# Imperial Valley College

## Americans with Disabilities Act Facilities Evaluation

# Americans with Disabilities Act Facilities Evaluation

SHEET 58

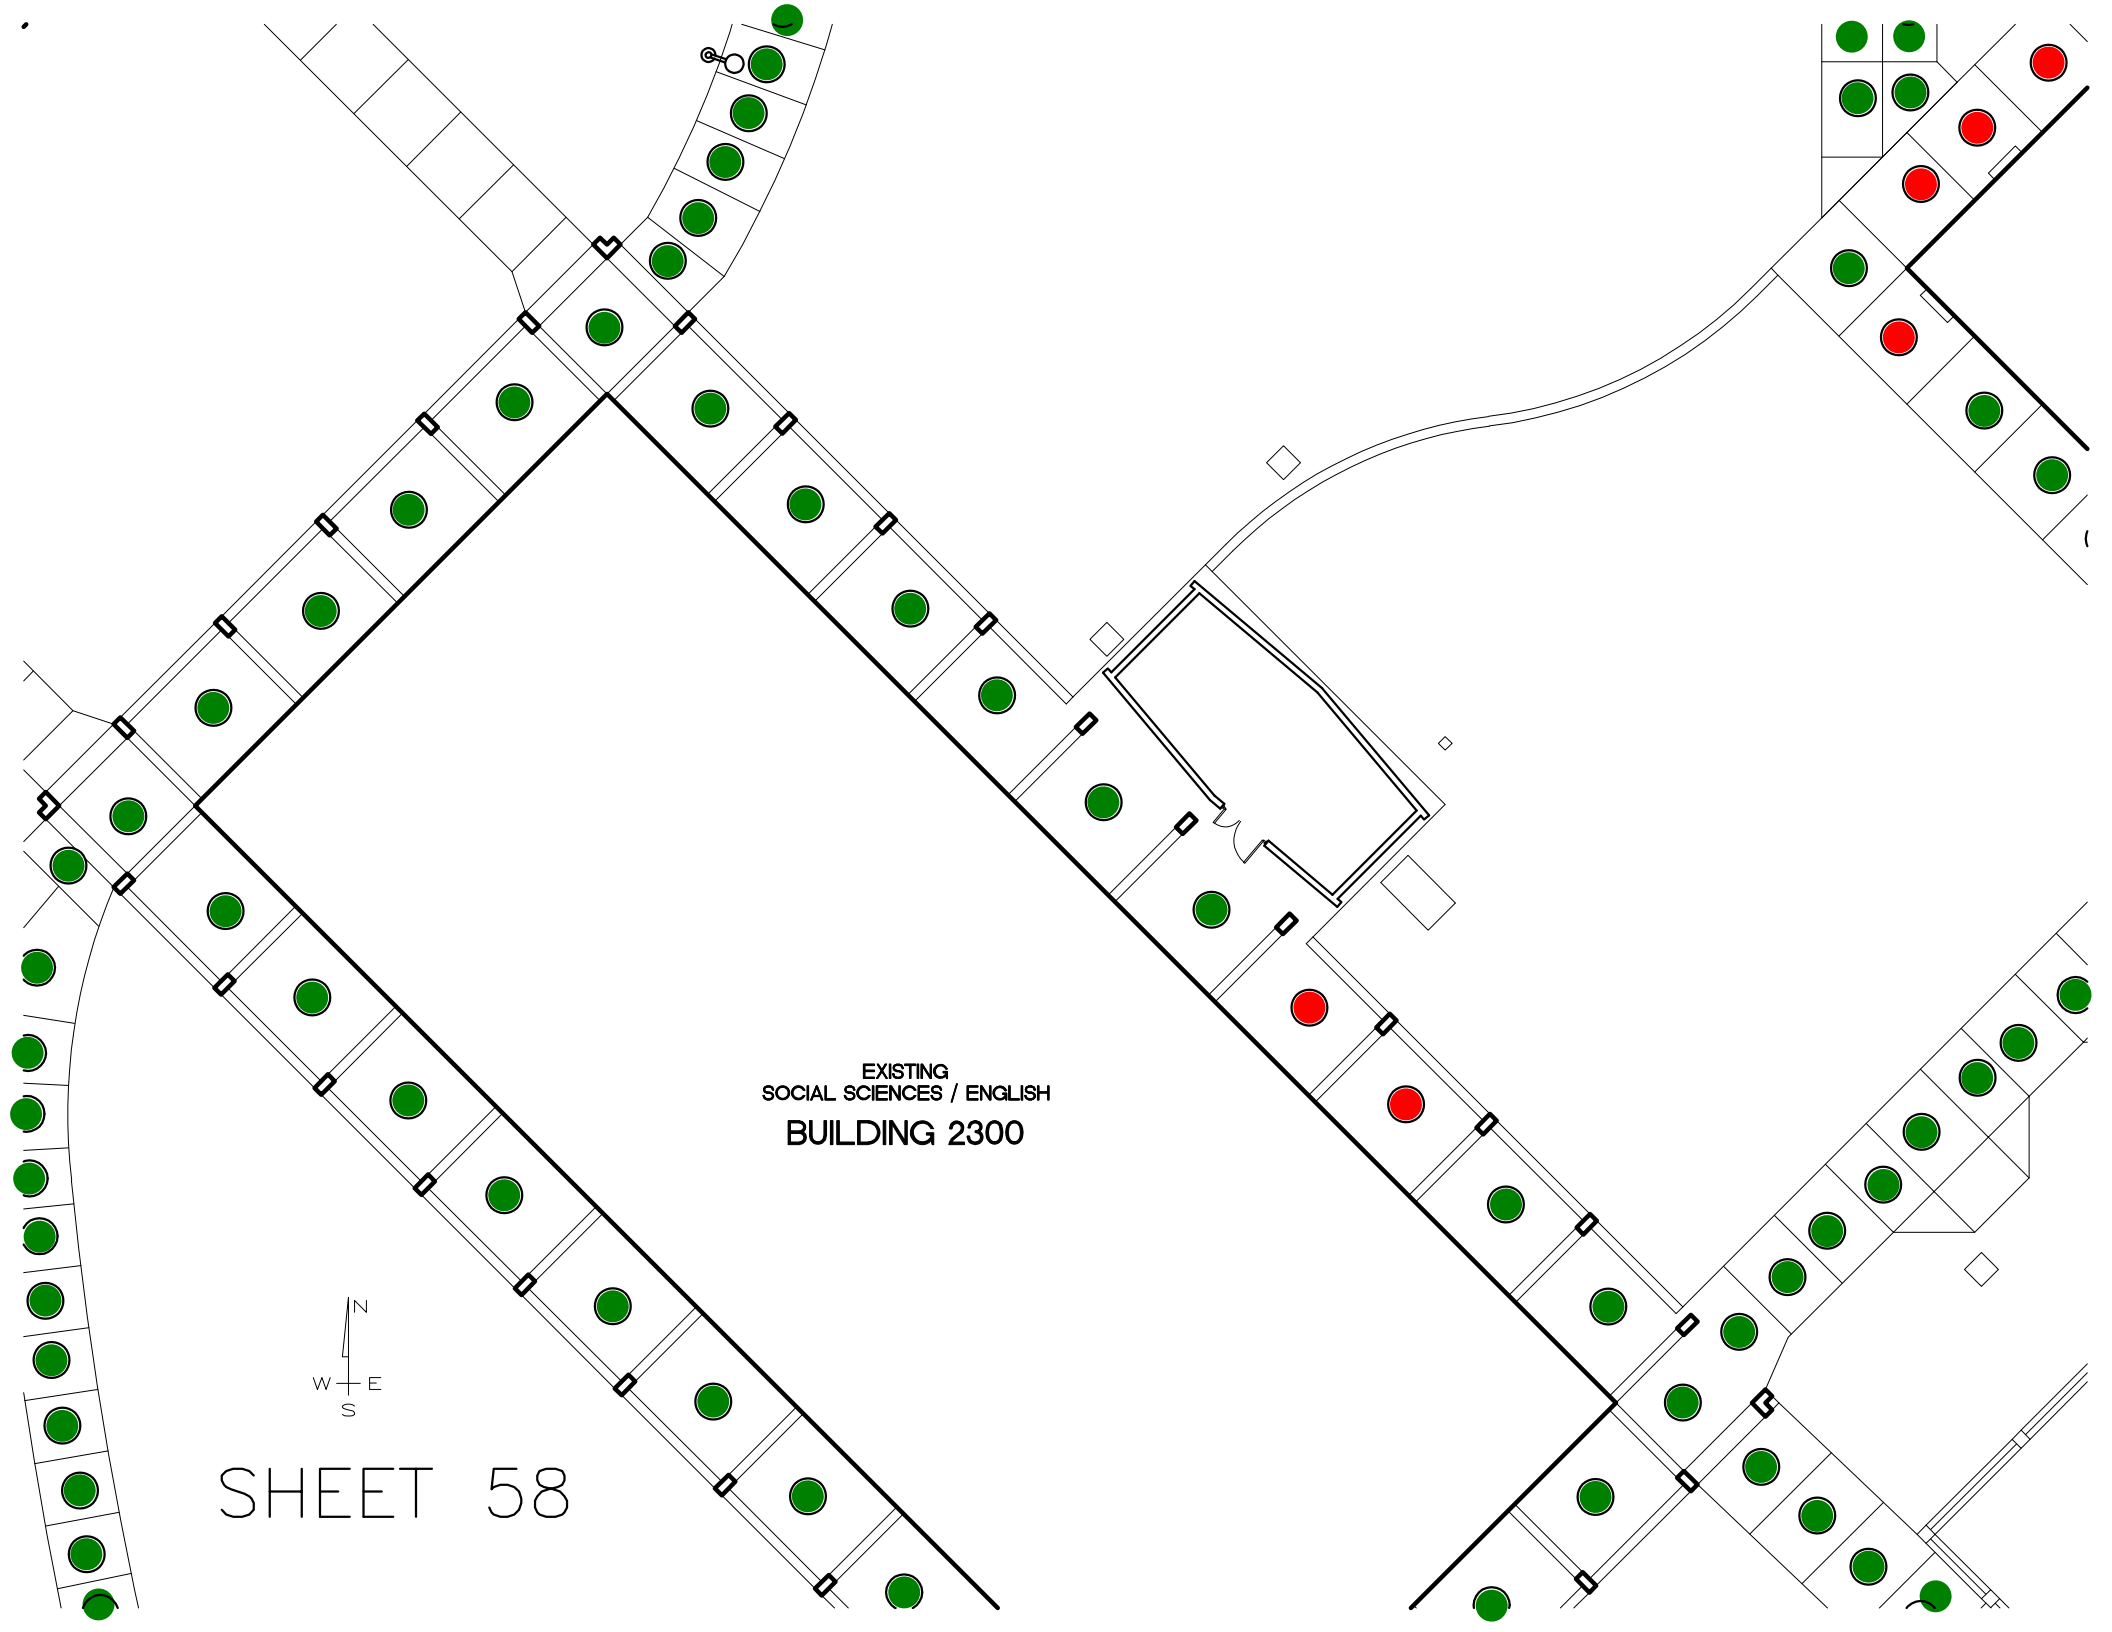
- Sheet 58: A couple sections of sidewalk with bad slope, elevation changes, gaping, and cracking around expansion joints, cracking across various sections of concrete.

SHEET 66

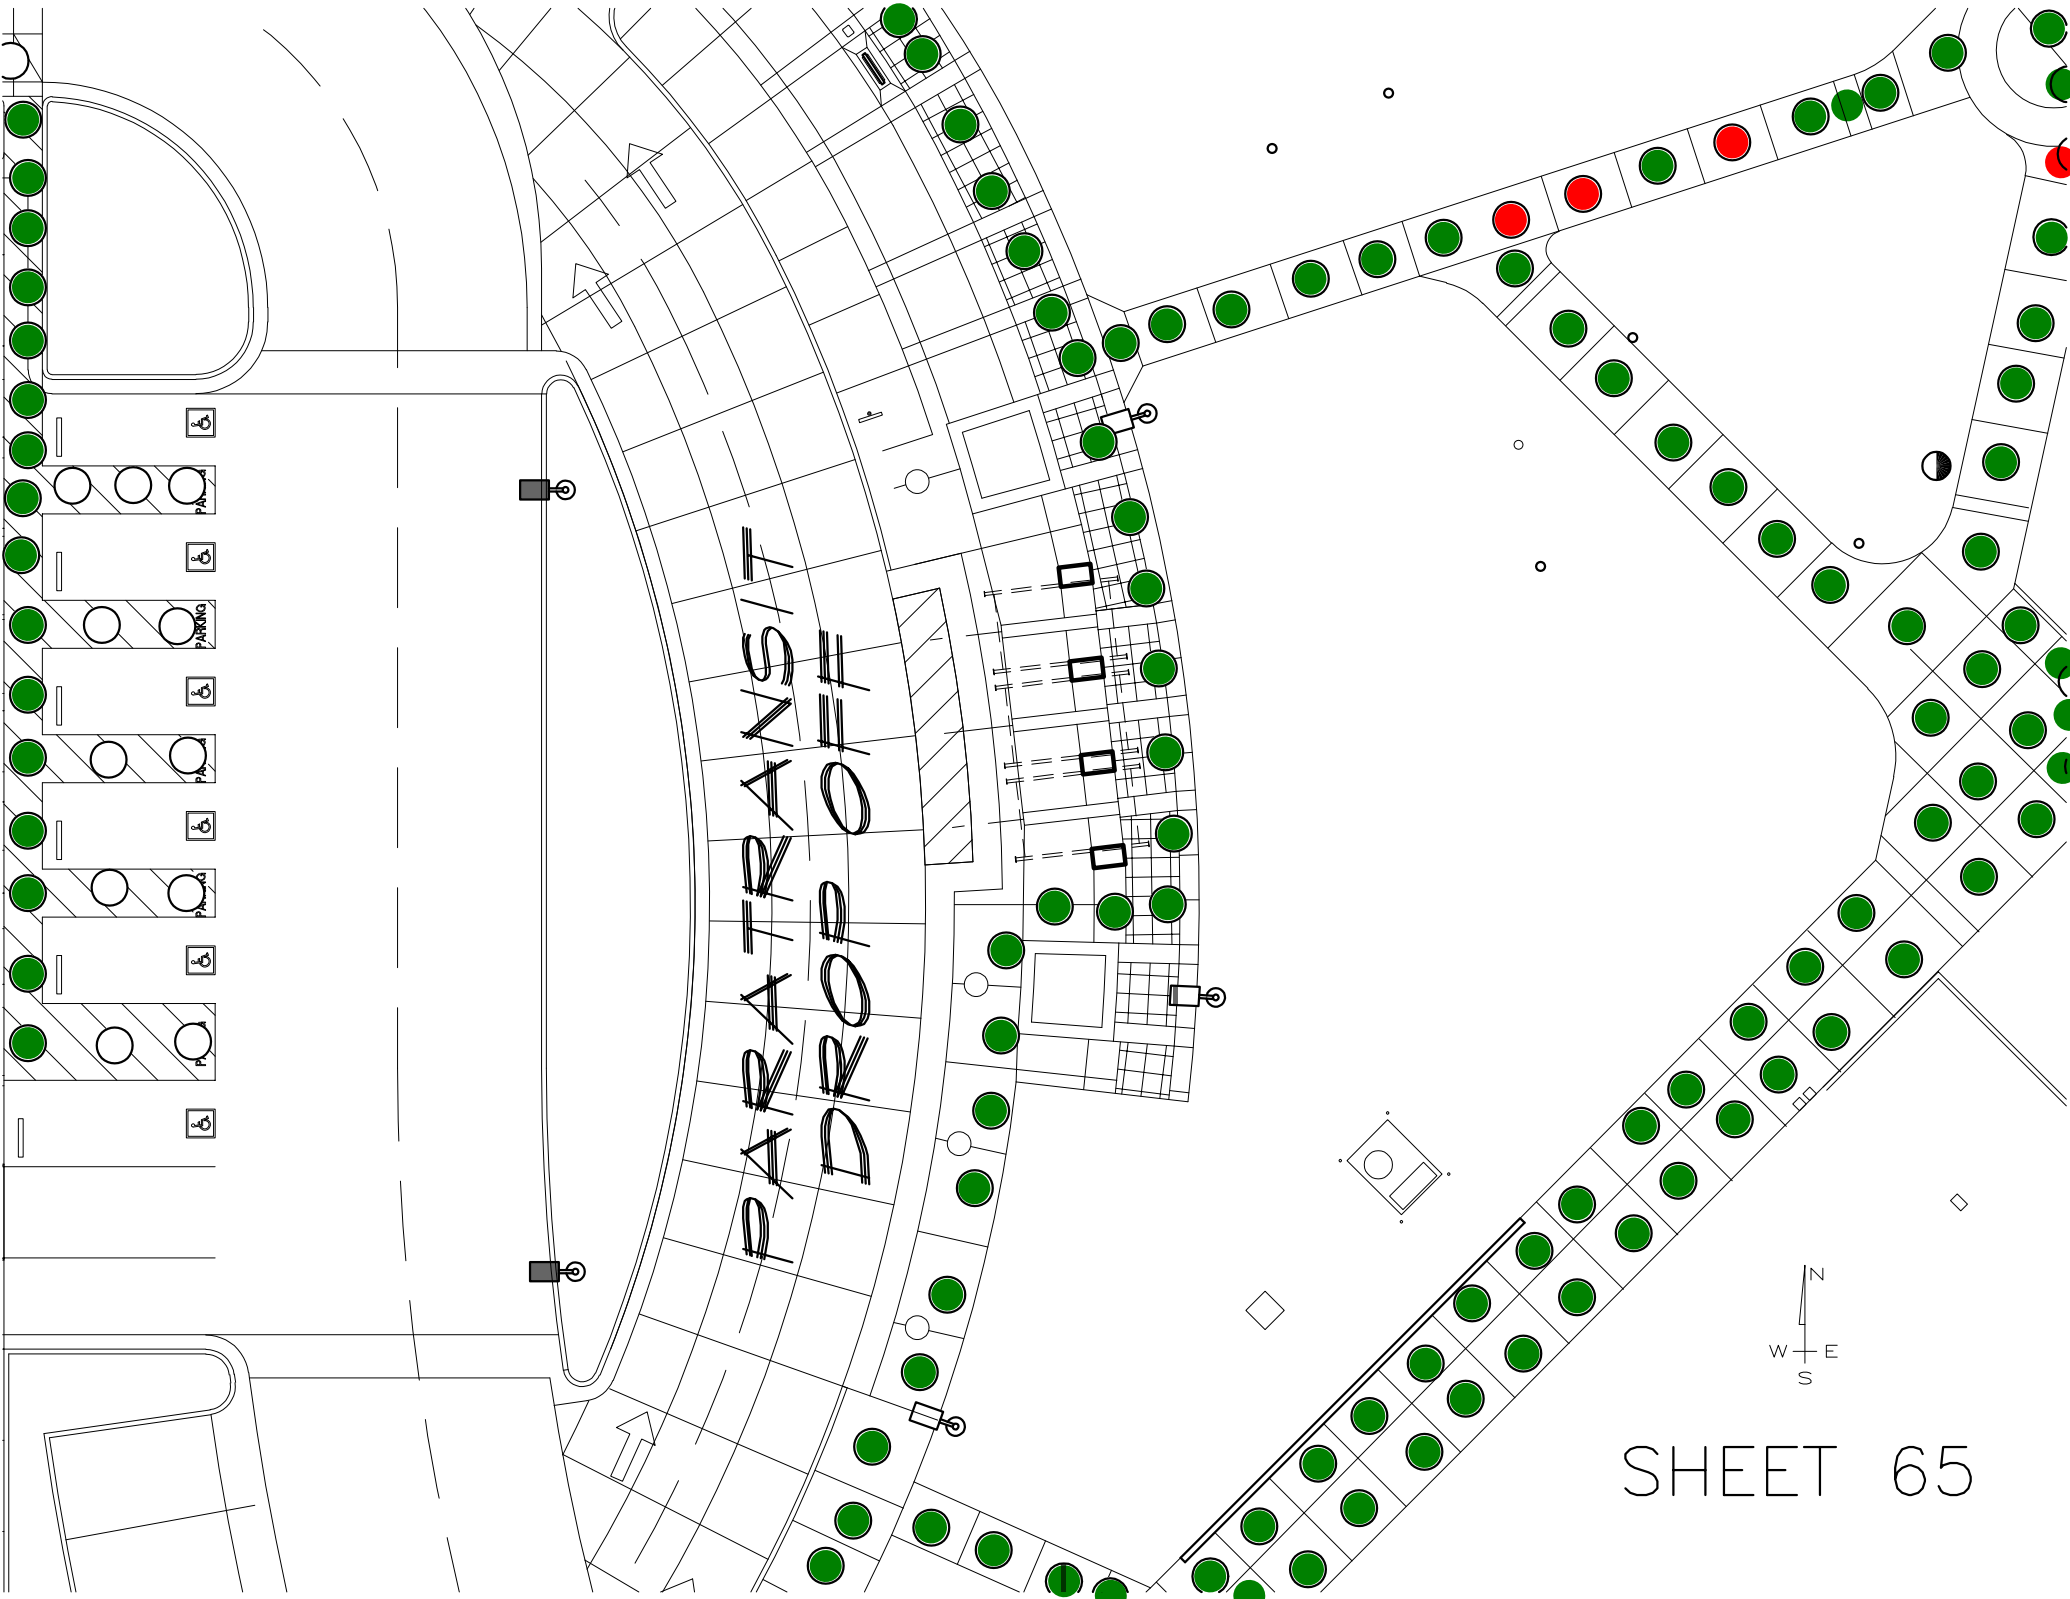
- Sheet 66: There is a large stretch of sidewalk that is less than 4' wide and has bad concrete, various sections of the sidewalk with bad slope, large cracks across the concrete causing lifting or sinking of the pathway, holes spread out across the concrete path, overall path of travel in the area is noncompliant.

- In **Sheet 63**, nearly the entire sidewalk was reported as noncompliant due to slope, and **Sheet 66** has a long stretch of path under 4' wide with severe slope and surface degradation.

SHEET 67

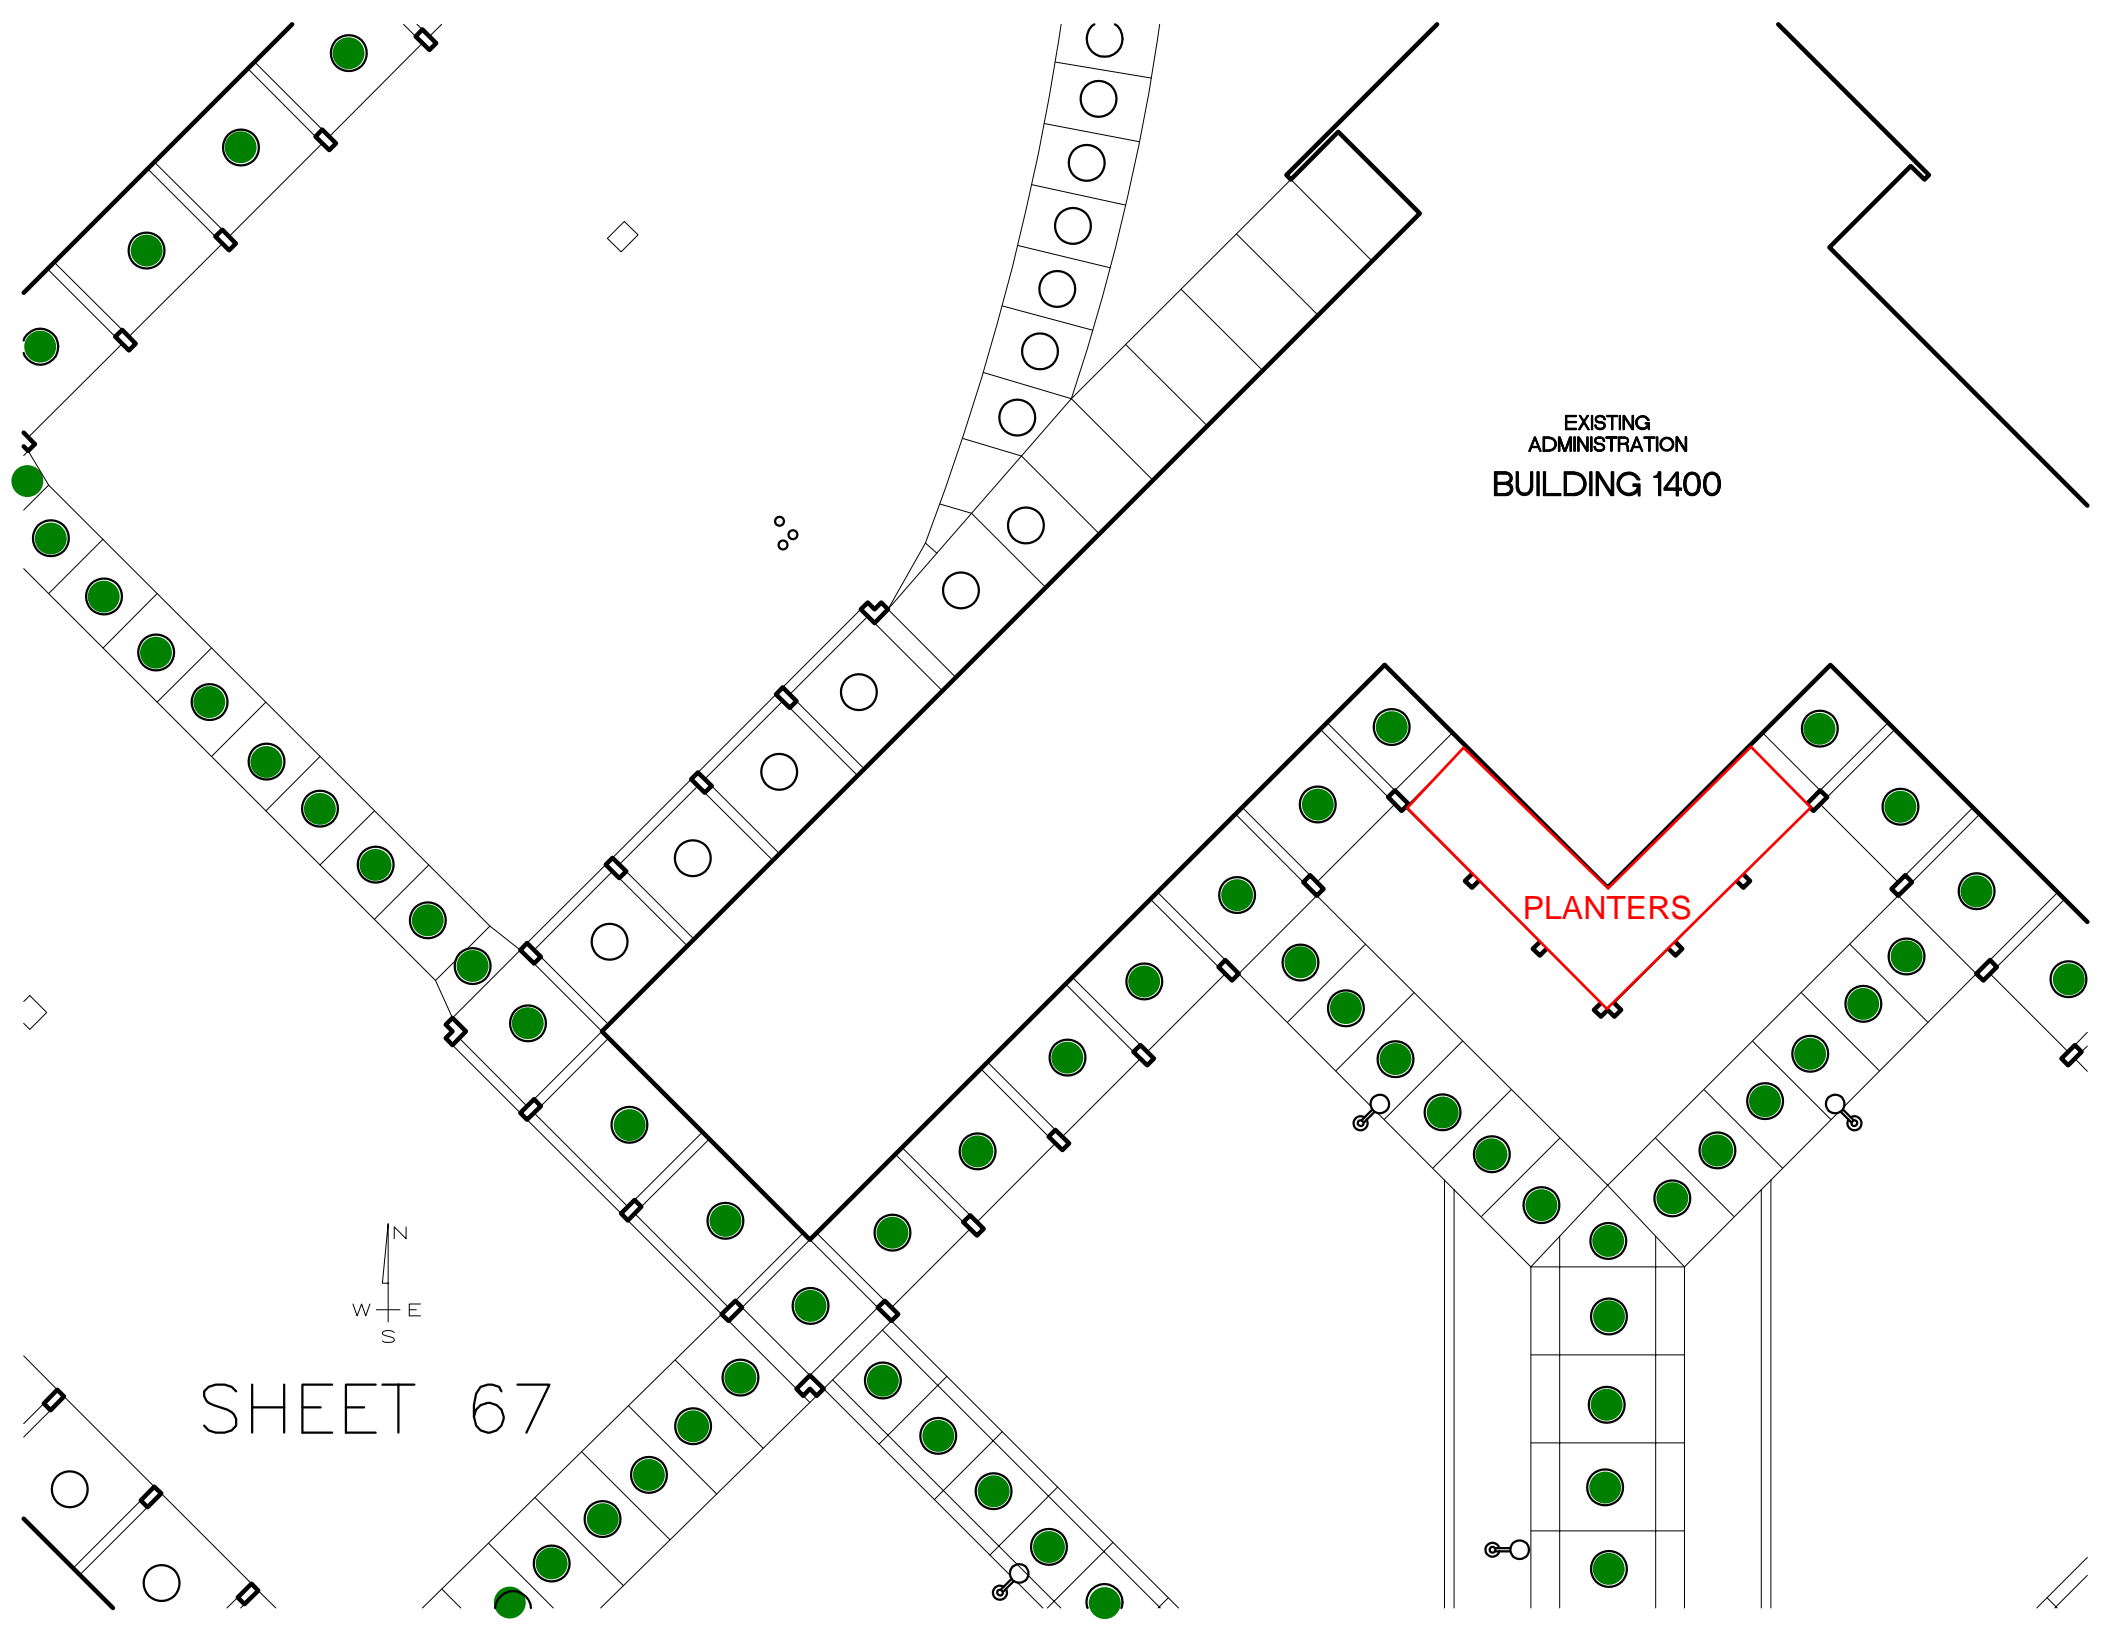
- 
- Sheet 67: Long cracks across various sections of the sidewalk, damage in expansion joints, and holes along cracks.
  - Sheet 68: Cracks and holes across various sections of the concrete path, gapes in a couple of expansion joints, and a single long stretch of sidewalk with bad slope.
